City of Aurora Building Division
Project: *TENANT IMPROVEMENT*
Address: *1400 S POTOMAC ST UNIT 150*
Occupancy Group: *B*
Construction Type: *IIB-SPK*
RSN: *1565796*
Permit: *21-2025590-LT*

City of Aurora Building Division
Reviewed for Code Compliance
Approved as Noted: *Matt A.*
Date: *Aug 11, 2021*
2015 INTERNATIONAL CODES & 2020 NEC

ALLPRIA

1400 S. POTOMAC, SUITE 150
AURORA, CO 80012

A1 **LEVEL 1**
1/16" = 1'-0"

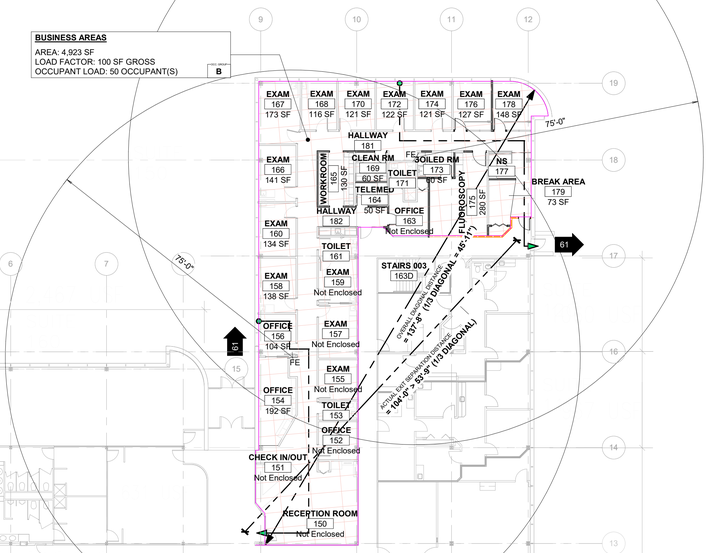
Provide a sign stating "EXIT" in raised, visual characters and braille adjacent to each door in an area of refuge, an exterior area for assisted rescue, an exit stairway or ramp, an exit passageway and the exit discharge. **2015 IBC 1013.4**
